METROPOLITAN GOVERNMENT OF NASHVILLE AND DAVIDSON COUNTY

Metropolitan Historic Zoning Commission
Sunnyside in Sevier Park
3000 Granny White Pike
Nashville, Tennessee 37204
Telephone: (615) 862-7970
Fax: (615) 862-7974

STAFF RECOMMENDATION
1720 Linden Avenue
August 15, 2012

Application: New Construction—addition; Partial demolition.
District: Belmont-Hillsboro Neighborhood Conservation Zoning Overlay
Council District: 18
Map and Parcel Number: 10416016300
Applicant: Van Pond, AIA
Project Lead: Melissa Baldock, melissa.baldock@nashville.gov

Rear façade showing existing additions to be demolished

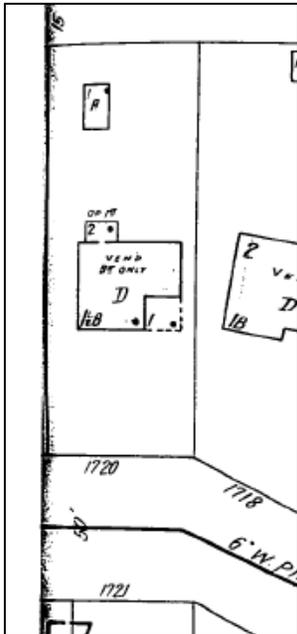
Partial Demolition: The applicant is proposing to demolish existing rear additions (see photo to right). The existing rear additions do not relate to the architectural or structural integrity of the house and are not original to the house. The rear additions do not appear on the 1951 Sanborn map (see map on next page); the addition that is indicated on the Sanborn does not match the footprint or location of the existing additions. Most of the original back wall of the house is no longer existing, but the corners of the house remain and will be retained as part of the new addition.

Based on the age, appearance, and lack of historic integrity of the rear additions, staff

finds that the rear additions do not contribute to the architectural and historic character of the house or the district and that their demolition meets Section III.B.2.b. of the *Belmont-Hillsboro Neighborhood Conservation Zoning Overlay: Handbook and Design Guidelines*.

Right façade, showing the existing enclosed porch, the gable field window to be altered, and the rear addition to be removed.

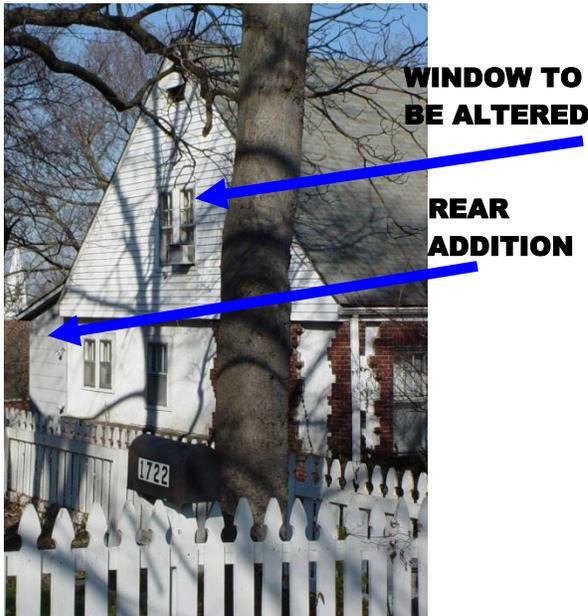
The applicant is also proposing to remove the enclosure of the porch on the front-right corner of the house (see photo below). The enclosure includes siding, a door, and an awning. The existing brick piers, brick veneer, stucco veneer, and roof rack will remain as part of the project. The 1951 Sanborn map indicates that this porch used to be open in nature but was enclosed at some point after 1951 (see map below). The design and materials of the enclosure do not add to the architectural or historic character of the house, and staff finds that the removal of the enclosure and re-opening of this front-right corner porch meet Section III.B.2.b. of the *Belmont-Hillsboro Neighborhood Conservation Zoning Overlay: Handbook and Design Guidelines*.

The project also includes enlarging the two gable field window openings on the side facades to allow for egress (see photo above and photo on next page). The existing openings are five feet by five feet, six inches (5' X 5'6"), and include two double hung windows. The new window openings will be seven feet by six feet (7' X 6') and will also include two double hung windows. Staff finds the alteration of the window openings to be appropriate because they are located on side facades, and the enlargement is relatively modest and will retain the configuration of two double hung windows. The gable fields' existing vinyl siding will also be removed and replaced with new smooth Hardie Plank

siding with a five inch (5”) reveal and with Hardie trim battens. Staff finds this to be appropriate since the existing siding is not original to the house and cladding alone is not reviewed in a neighborhood conservation zoning overlay.

Proposed North Elevation (Rear)
1"=8'-0"

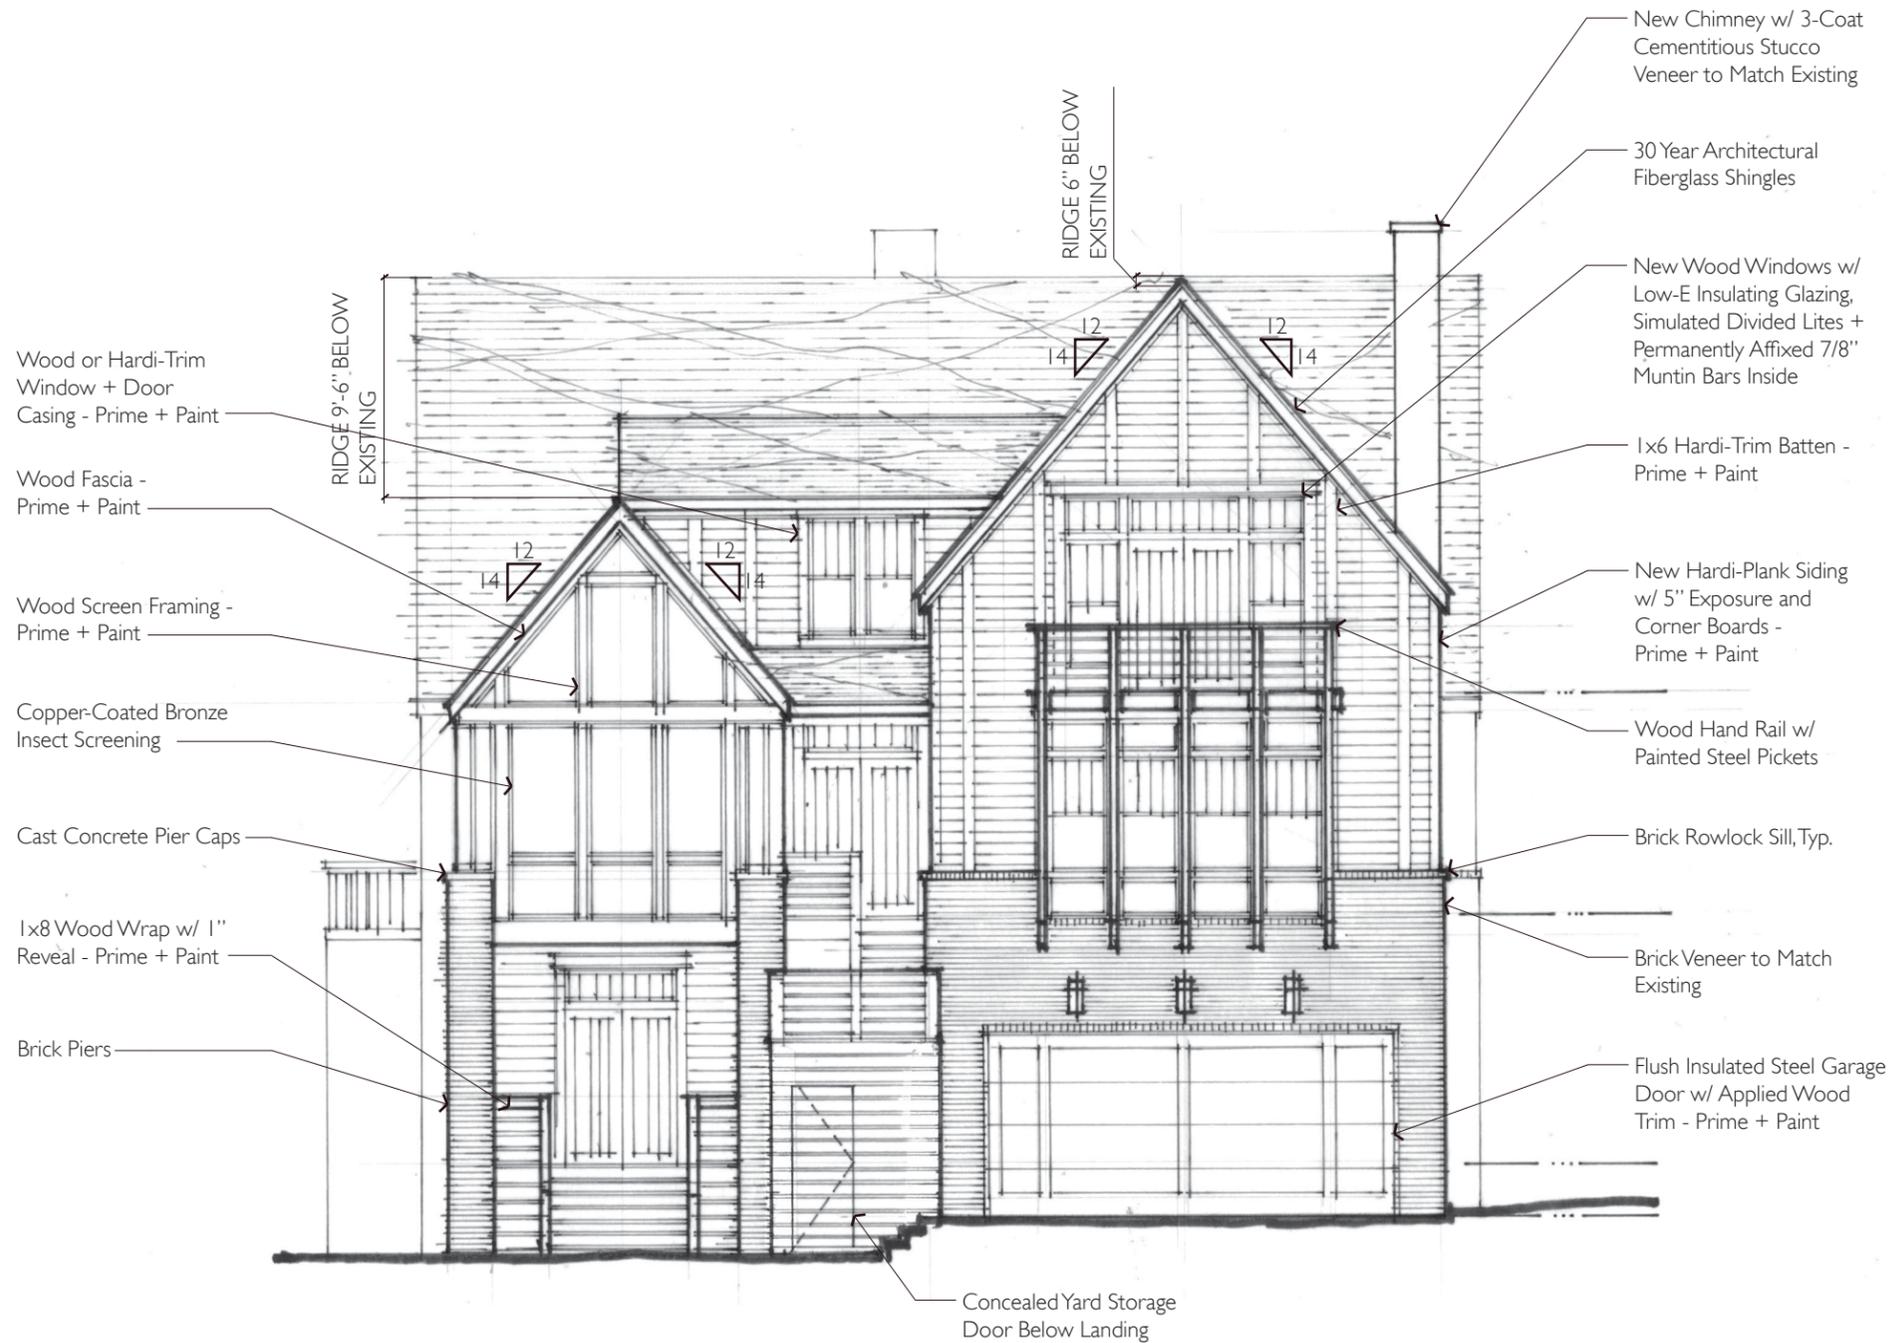
Roof: The existing house has a cross-gabled roof with a slope of approximately 14/12. The rear addition will have two separate gable forms with a 14/12 slope. The two forms will be connected with a shed roof with a slope of 3/12. Shed dormers with a slope of 3/12 will also be constructed off of the back slope of the house's roof and on either side of the addition's western gable. Staff notes that the right (east) and rear elevation drawings do not show the dormers on the western gable of the addition, and staff asks that a condition of approval be that the applicant submit revised right and rear façade drawings to show the dormers.

With the condition that new right and rear façade drawings be submitted, staff finds the addition's roof pitches and forms to meet Sections II.B.1.e. and II.B.2.a. of the *Belmont-Hillsboro Neighborhood Conservation Zoning Overlay: Handbook and Design Guidelines*.

1. The applicant submit revised drawings for the right/east façade and the rear façade showing the dormers proposed for the western portion of the addition.
2. Staff review and approve the asphalt shingle color, all window and door specifications, and a brick sample prior to purchase and installation of these materials.
